SUBMISSION
TO
QUEENSLAND FLOODS
COMMISSION OF INQUIRY

SUPPLEMENTARY SUBMISSION

by
Greg McMahon

30 March 2011

TABLE 1: UNDERSTATEMENT OF FORECAST LEVELS FOR WIVENHOE DAM
9-11 JANUARY 2011

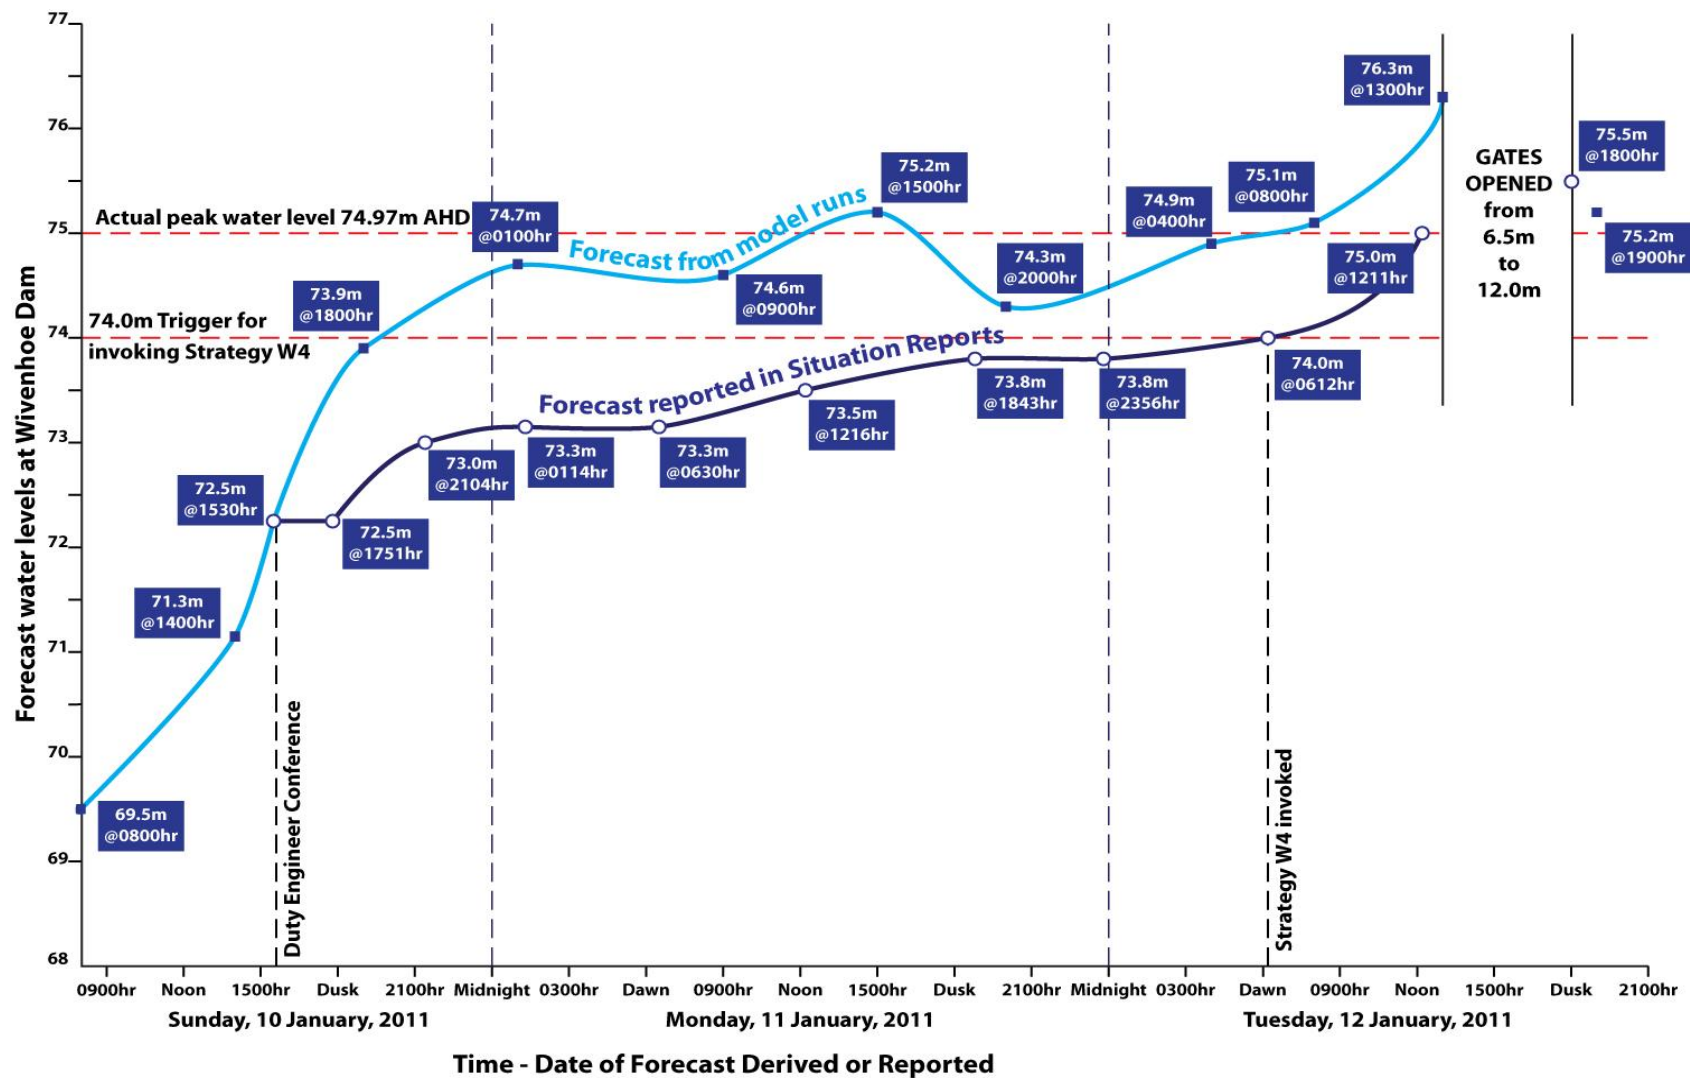
Figure 1 places this material in graphical form.

The data appears to be information tending to show that forecast reports of Wivenhoe Dam water levels were in significant error. The fact of the error arises when the reported forecasts are compared with the water levels forecast by the hydrologic modeling of measured and forecast rainfalls. These model runs were made before and immediately before the forecasts in error were reported in Situation Reports and Technical Situation Reports to other stakeholders.

The error appears to have originated after 3.30PM (or 15.00) on Sunday 9 January 2011.

This is the time when a last forecast was made where the reported forecast, and the estimated hydrologic model forecast (estimated from the sequence of forecasts from model runs), were approximately the same (see Figure 1).

The error, thereafter, ranged from 0.5metres to 1.5metres

RECOMMENDATION 1: That an explanation be sought from the public officers who received the model run results as to the source of the Wivenhoe Dam water level forecasts provided in the Situation Reports with the reasons for not using the results of the RTFM model run results.

Figure 2: (abbreviation of Figure 1 on Page 8)

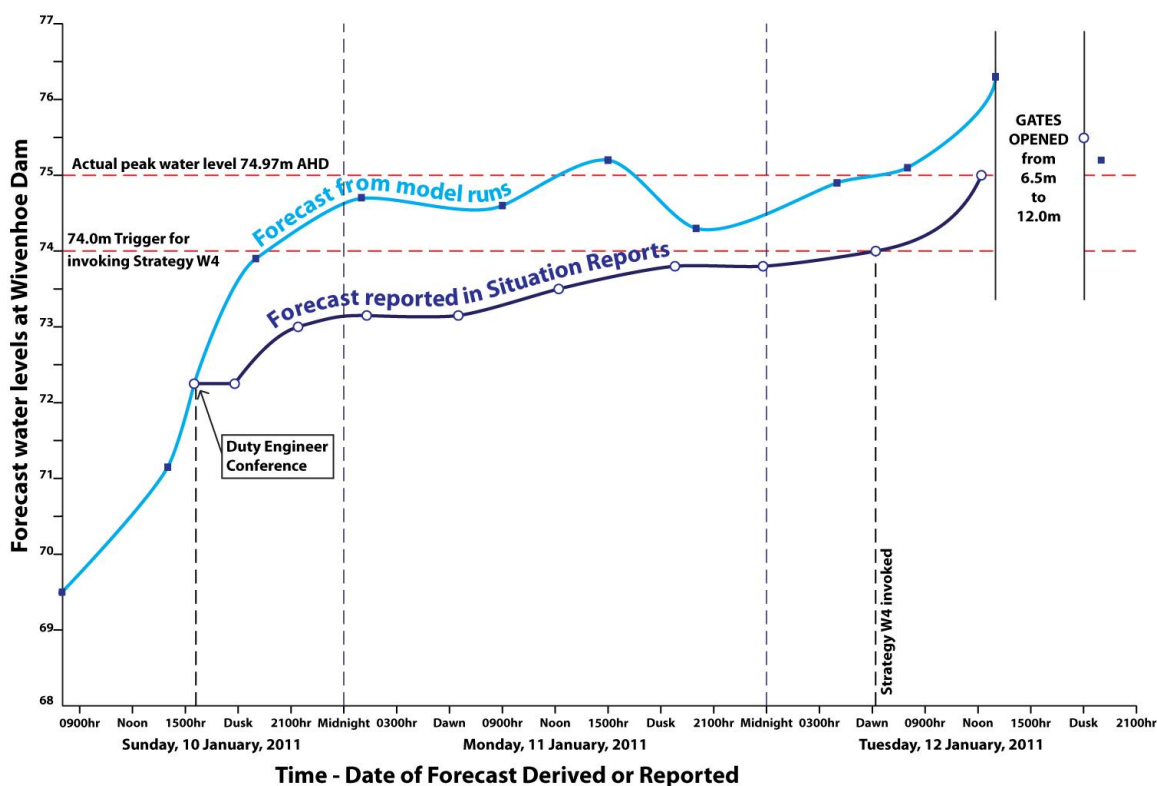
The period, *‘between 03:00 to 15:00 on Tuesday 11 January 2011’* coincides with the period of greatest error between the forecasts of Wivenhoe Dam level given by the model runs and the forecasts reported in the Situation Reports. Refer to Figure 1 or an abbreviation of Figure 1 at Figure 2 below.

A question then may arise as to whether or not there is any link between this error in reported forecasts of water level and the volume of water that needed to be found to explain the *‘rapid rise’* in the water levels. The possibility may exist that the rapid rise may have been caused by the need to adjust across the difference in forecast water levels illustrated on Figure 1 (and on Figure 2).

Without a satisfactory explanation as to the differences between the forecasts of water level given by the model runs and by the Situation Reports, it may be reasonable to examine the accuracy of all levels reported in the Situation Report, including the water levels in the Dam reported as ‘existing’ at the time of each Situation Report.
